STATE OF NORTH CAROLINA
DEPARTMENT OF TRANSPORTATION

SUBJECT: **Permit Modification Request for TIP No. R-2231B**, Richmond County,
Federal Aid No NHF-45-1(49), State Project No. 8T550803, NCDOT
Division 8, \$475.00 Debit work order 8T550803, WBS Element No.
34398.1.4, NCDOT Division 8

Reference: USACE 401 Individual Permit Action ID 199400590, issued July 11,
2003, condition 2e, 2f, 2g, 2i; and DWQ 401 Major Water Quality
Certification, Project No. 000874 issued on April 1, 2003, condition 9.

PROJECT: 8.T550802 (R-2231B)

SHEET 28 OF 43

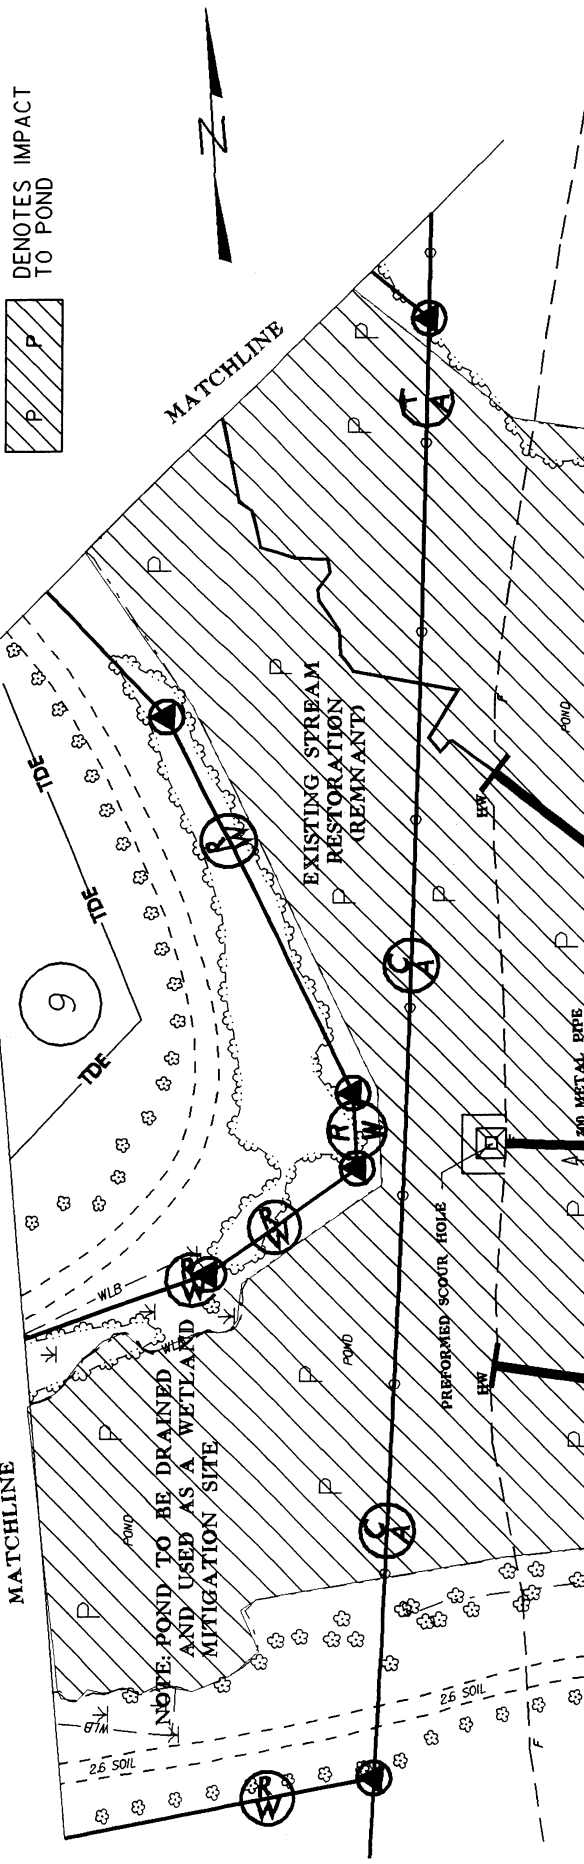
Site 6, Sheet 28 of 43

Station 140+20 TO Station 141+40-L-(Rt)

Eliminate the stream relocation design below the proposed roadway. A step-pool channel is proposed through the dam to stabilize this site. See attached hydraulic plans and supporting data.

Mitigation change: elimination of 249 linear feet of Natural Stream Design

Profile of Channel Through Dam

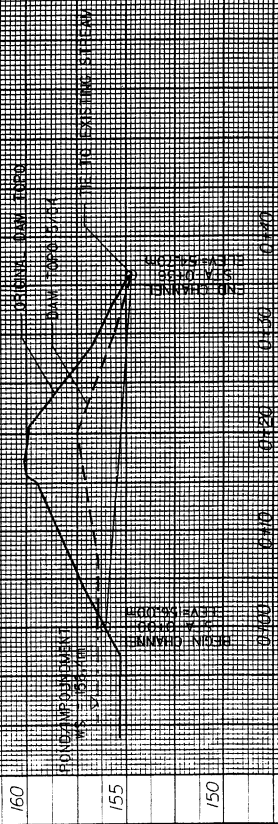
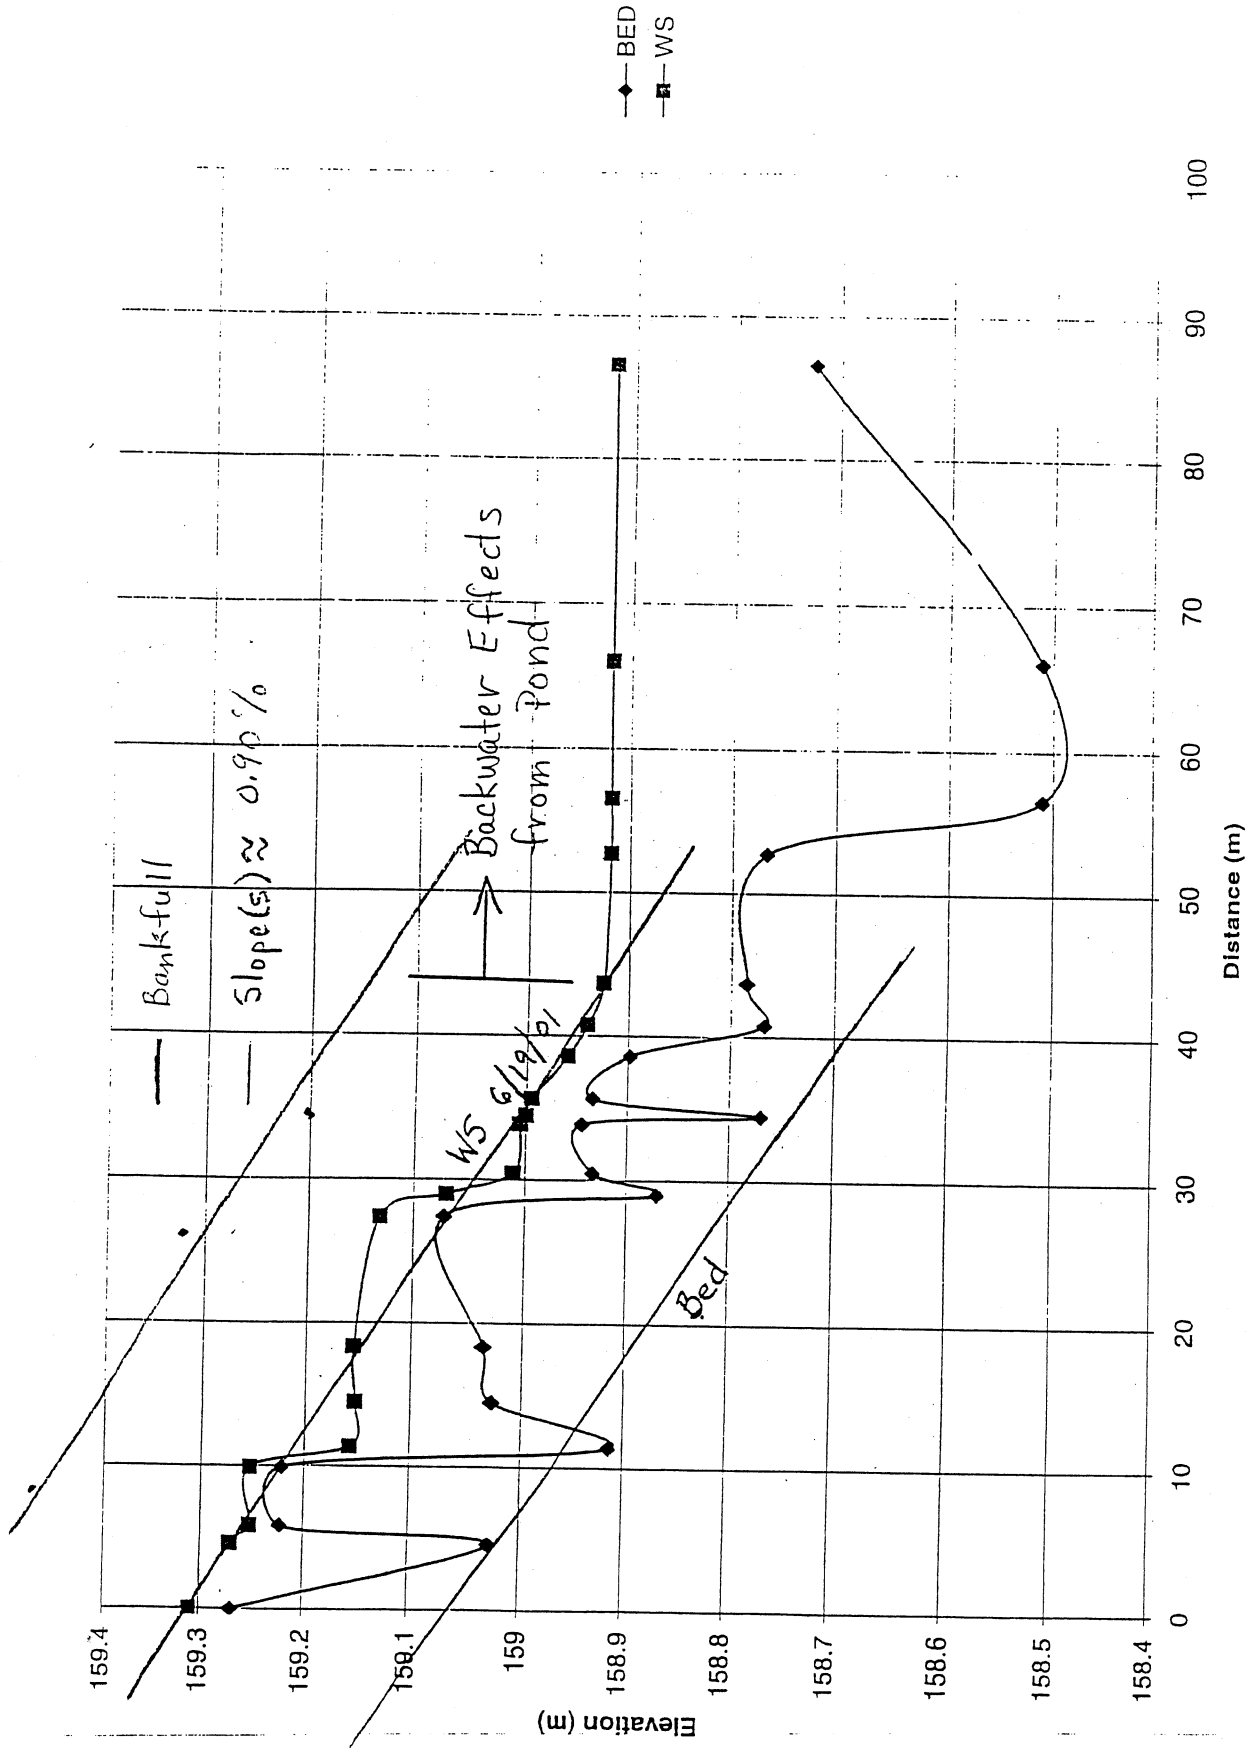
The impoundment design and mitigation losses were analyzed and resubmitted on 5/27/04. It is proposed to remove the 900mm CSP riser and lower the existing dam. The riser will be removed to eliminate future maintenance issues. The existing dam will be lowered to approximate elevations of 156.5m at the head of the pond to 155.2m at the tail of the pond. Also, it is proposed to construct a step-pool channel through the dam. The channel invert elevations are approximately 156.00m at the head of the pond and 154.7m at the tail of the pond. The channel will have coir fiber mat on the banks along with the footer rocks and streambed material at the step-pools. The width of the dam excavation has been designed at 45m but may be wider if needed. Toe protection has been proposed along the fill in the impoundment to an approximate elevation of 156.5m.

The drainage area at the existing dam is 193 acres. The basin is rural and is located in the Sandhills hydrologic region. The basin drains pine/hardwood forest and agricultural fields. The channel through the dam was designed based on Piedmont regional curves. This produced a bankfull discharge and area of 37 cfs and 9.5 ft², respectively. The Piedmont curves were used at this location since they are more conservative than the numbers generated by the Coastal curves (7 cfs and 6.6 ft²). As a backup, the 10 yr discharge generated by the USGS Rural Equations for the Sandhills region was 32 cfs. This reconfirmed a conservative discharge and cross section for the step-pool channel. The 50 yr discharge at this location is estimated at 53 cfs.
